Mulberry Close – CGI Comparison of Key Views Study

After being selected by the residents of Mulberry Close to deliver this stalled site Fruition Properties (FP) have worked with our external design team, engineers and internal technical specialists to identify and amend all the buildability issues in the extant consent as well as to improve the quality of living accommodation for future occupiers.

View A) Downage

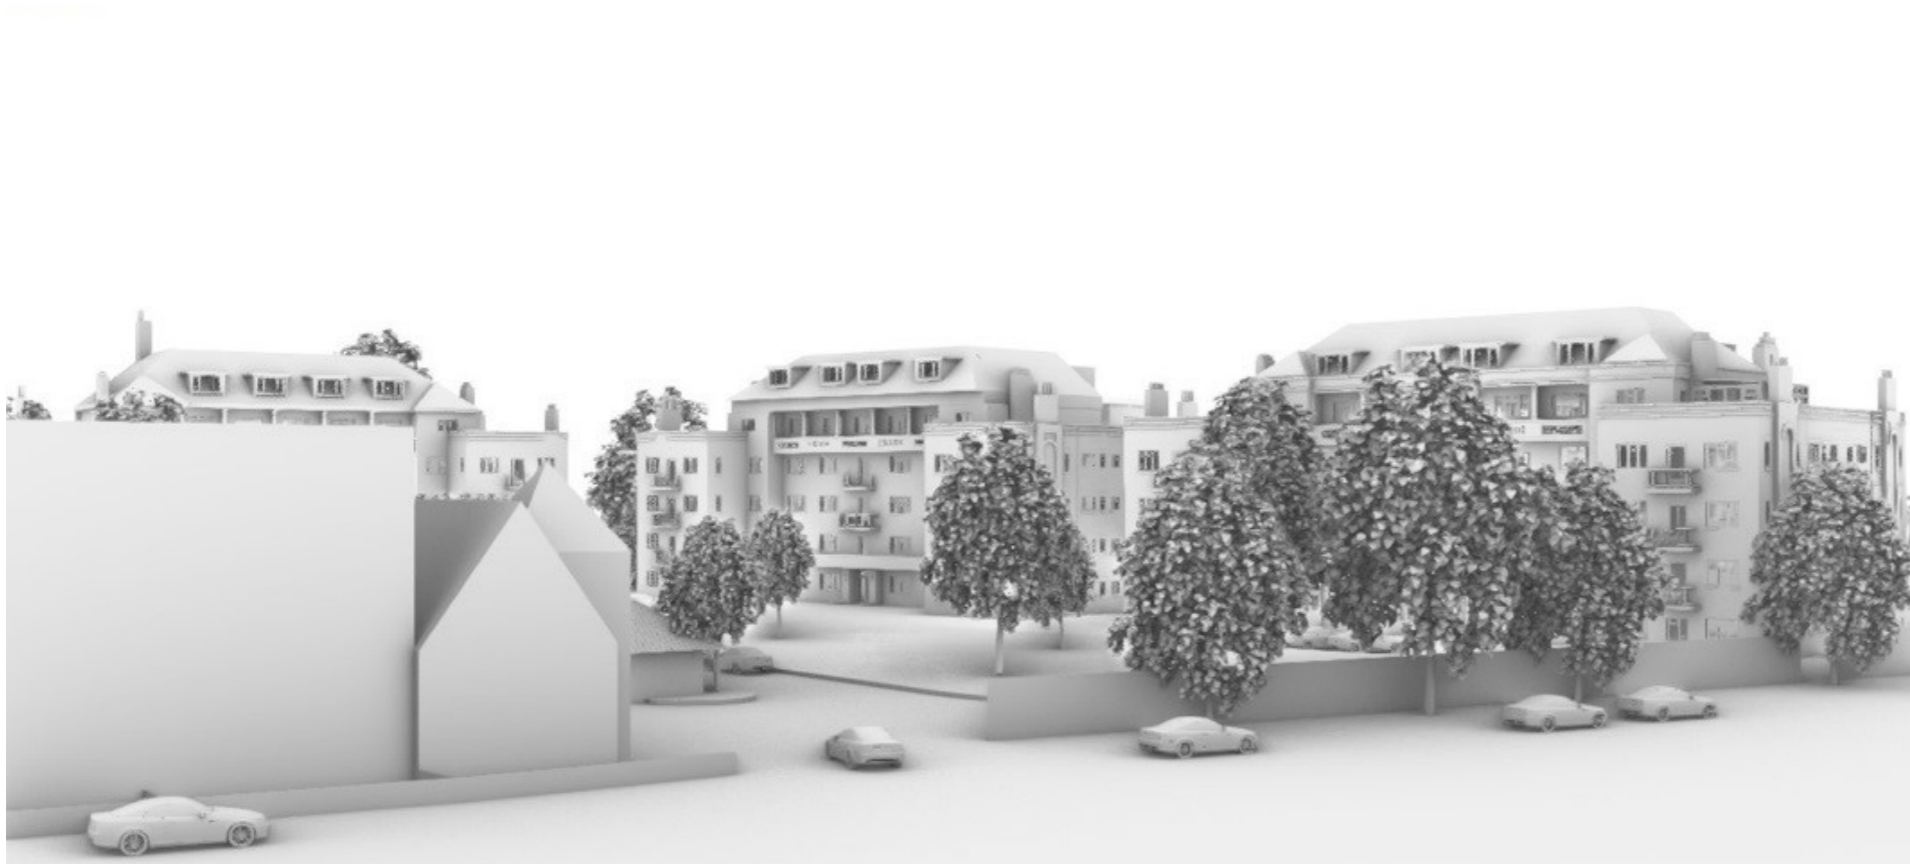
Following feedback from the planners we have worked to minimise the additional height required, meaning the additional height requested is just c.350mm over that consented, representing a very marginal increase, protecting (and we believe) enhancing the form of the building.

To improve the quality of the internal layouts we have also sought to extend the new homes into the terraces. We have worked with the LB Barnet Design Officer to determine the optimal location for the rear boundary of the new apartments and have undertaken analysis of the key views to determine this balancing the additional massing against the improvements to accommodation.

As such, we have moved the rear boundary outwards by c. 450mm on Pembroke Hall and pushed back the rear wall of Courtney House to be in line with the chimneys (which help obscure it from the key views).

View B) Entrance

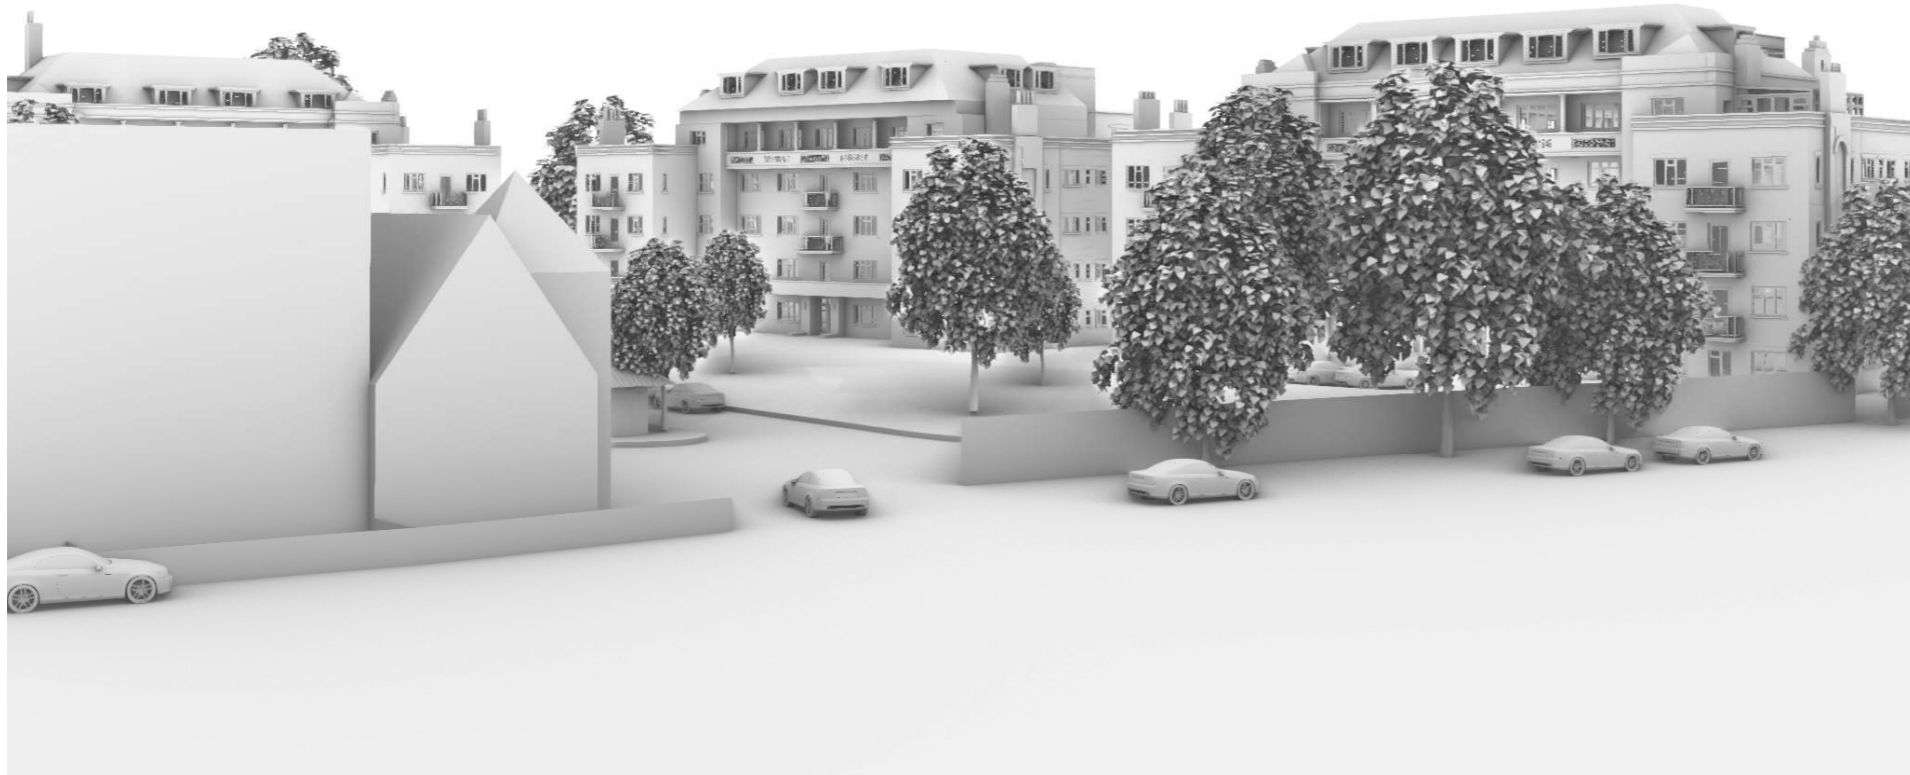
The proposed changes do not alter the massing of Thurlby Croft as the additional floor area is concealed behind the roof ridge line.

Thurlby Croft cannot be seen from further up Parson Street due to the large number of evergreens.

View D) Pedestrian passage

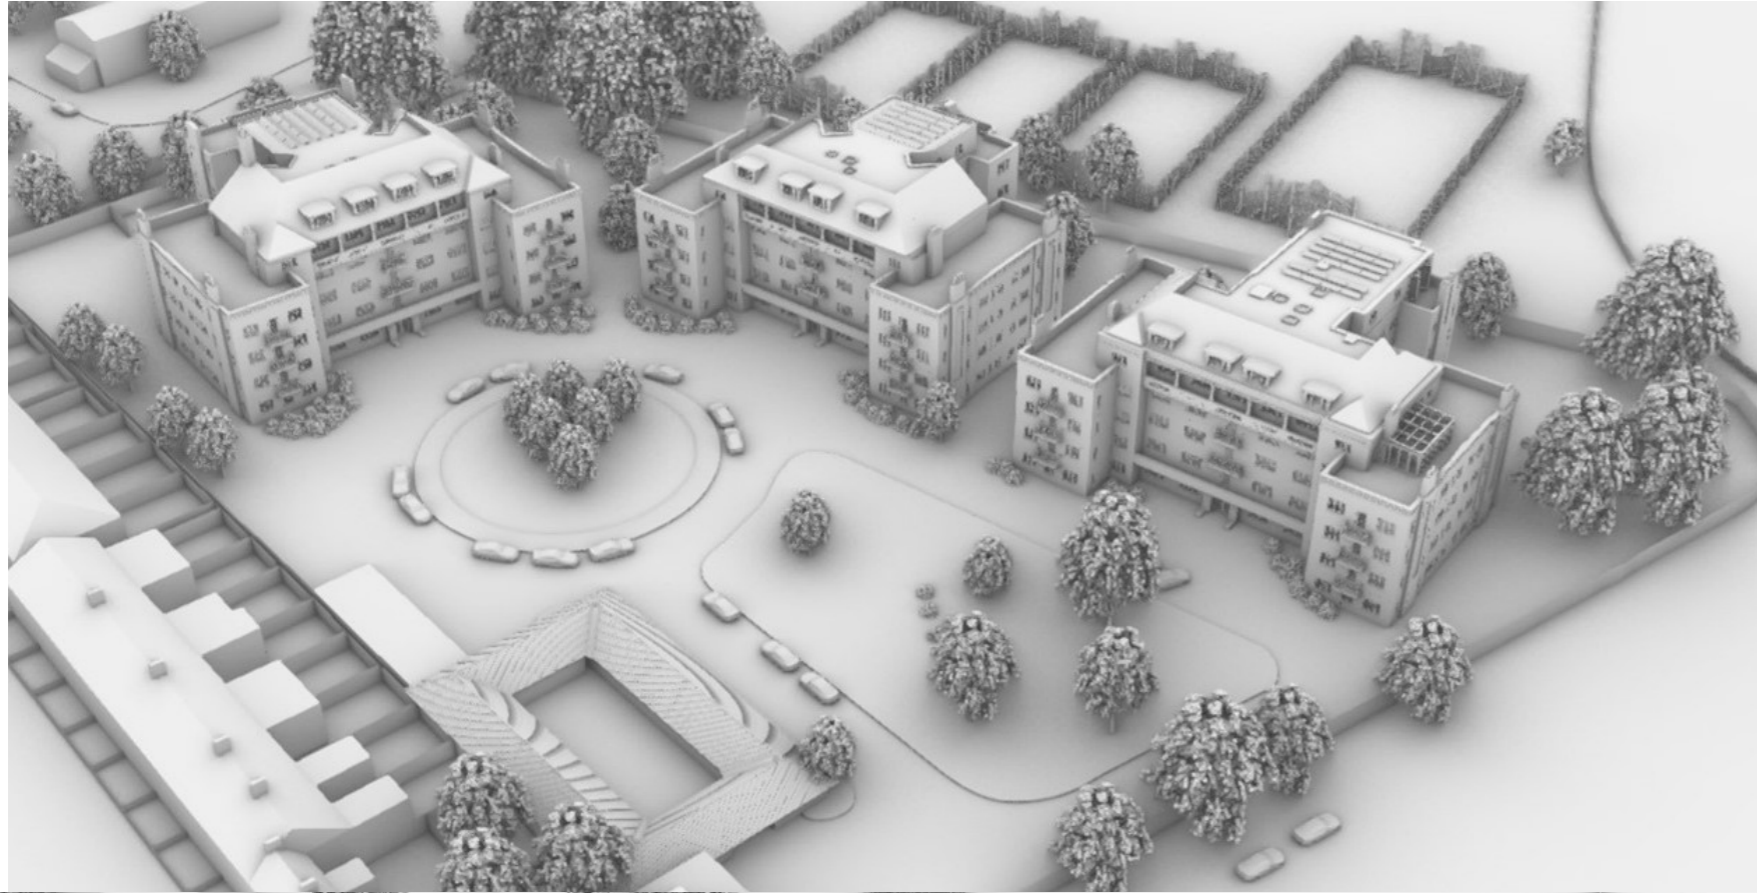
The dormers break up the flat area of tiling and improve the appearance of the blocks as well as significantly improving the internal layouts.

Following further consultation with the residents we have slightly reduced the size of the dormers from the level shown here (from 1500mm to 1200mm) to match the size of the windows on this elevation. This delivers the improvements to the living accommodation but means they are more in keeping with the scale of this elevation.

We have also removed the parapet detailing as the residents were keen to maintain subtle differences between each of the blocks. We originally proposed a c. 650mm extension and introduced the parapet to help maintain the subordinate proportion of the pitched section of roof; however, we worked with our design team to reduce this down to the minimum buildable level and believe this is no longer required.

View E) Sunny Gardens

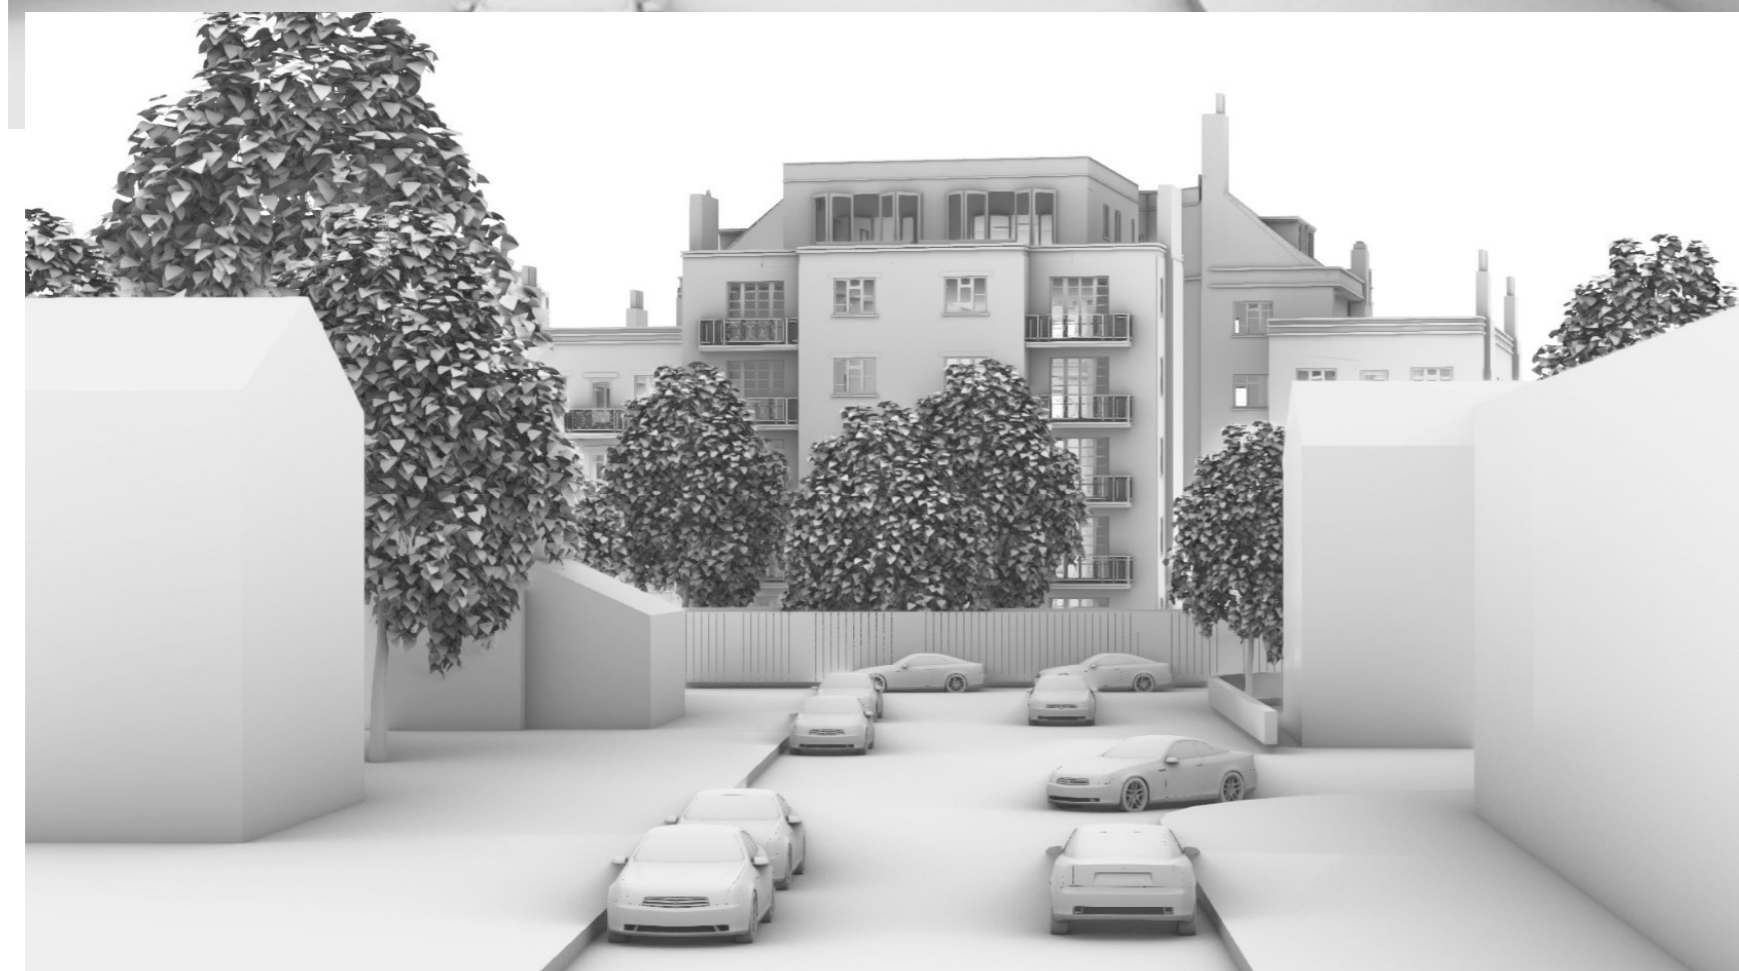
The rear wall on Courtney House has been extended so that the flat terminates in line with the rear of the chimneys. This follows the natural line that is dictated by the existing building and will mean that we conceal the additional massing, however we will still be able to achieve the improved layouts at this point.

We also amended the balustrading from glass to a bespoke metal balustrade, which as a traditional material would be more in keeping with the existing. No objections were raised in the pre-app to altering the glass to metal balustrading.

Following a review of the art deco precedents (p9) we added a render band to articulate the termination of the building. The Design officer accepted the principle however raised concerns as to the thickness of the render band, which has been reduced in the submitted drawings from what is shown in the CGIs to a 225mm deep render band with 75mm deep capping.
